# Access Compliance Report

## Public Rights-of-Way

Intersection ID: 10024743	Main Street: DEER RIDGE LN	Cross Street: N/A	Location: SE
ADA ID: DE14597CF05A	Ramp Type: PerpDiag	Initial Pass/Fail: Fail	Overall Compliance: No
		Severity Score: 25

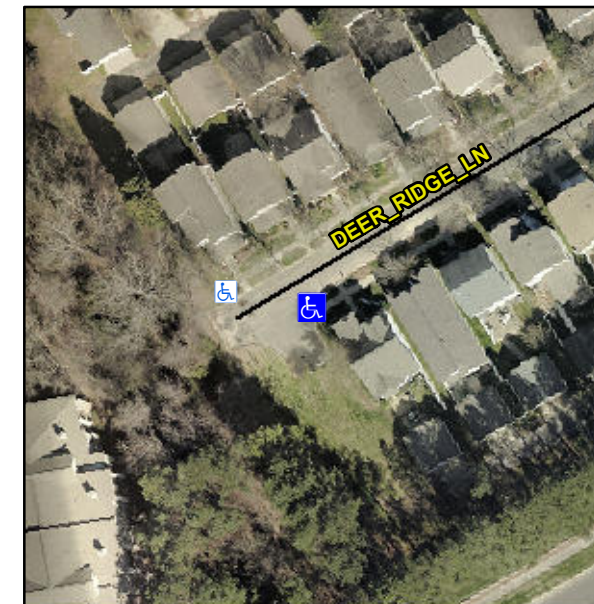
**Not Found, R304.2.2**

Compliance	Description	Data	Compliance	Description	Data
N/A	Ramp Length (in)	42.0	No	Ramp Slope (%)	12.7
Yes	Ramp Width (in)	53.0	Yes	Ramp XSlope (%)	1.6
N/A	Flare Type LT	N/A	N/A	Flare Type RT	N/A
N/A	Flare Slope LT (%)	N/A	N/A	Flare Slope RT (%)	N/A
N/A	Flare Traversable LT?	N/A	N/A	Flare Traversable RT?	N/A
N/A	Landing Length (in)	N/A	N/A	DWS Provided?	N/A
N/A	Landing Width (in)	N/A	N/A	DWS Contrast?	N/A
N/A	Landing Slope (%)	N/A	N/A	DWS Length (in)	N/A
N/A	Landing X Slope (%)	N/A	N/A	DWS Full Width?	N/A
N/A	Landing Curb? (Y/N)	N/A	N/A	DWS Offset (in)	N/A
N/A	Shared Landing?	N/A			
N/A	Gutter Ponding?	N/A	N/A	Gutter Slope (%)	N/A
N/A	Gutter Lip Ht (in)	N/A	N/A	Gutter X Slope (%)	N/A
N/A	Painted X Walk1?	No	N/A	Painted X Walk2?	No
	X Walk 1 Direction	To N		X Walk 2 Direction	To W
N/A	X Walk 1 Width (in)	N/A	N/A	X Walk 2 Width (in)	N/A
	X Walk 1 Slope (%)	2.4		X Walk 2 Slope (%)	1.4
	X Walk 1 X Slope (%)	2.7		X Walk 2 X Slope (%)	1.9

**Remove & Replace Curb Ramp With Two New Directional Ramps or Equivalent.**
